X 95.011-26

Model Master 43RC

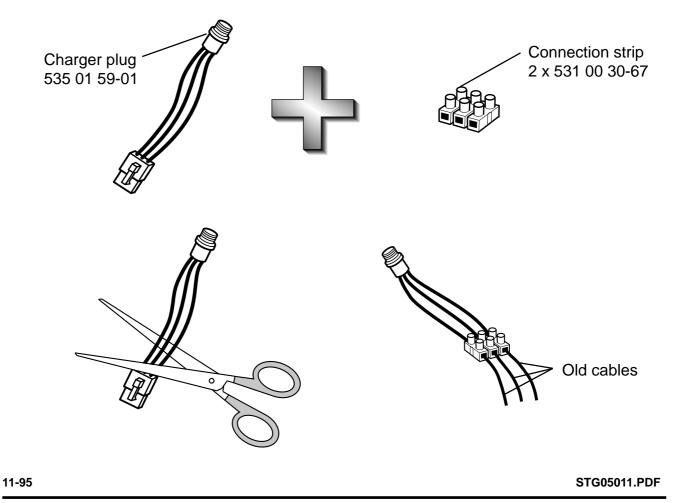
As from 1996 models the cable can be separated thanks to a quick connector by the charger plug. This is to ease changing charger plugs if necessary.

If the charger plug needs to be changed on older cables (95 and earlier), the new plug is used with a connection strip.

- 1. Cut off the defective charger plug.
- 2. Strip the three cable ends.
- 3. Fit these to the connection strip.
- 4. Cut off the quick connector from one 535 01 59-01.
- 5. Strip the three cable ends.
- 6. Fit these to the connection strip.
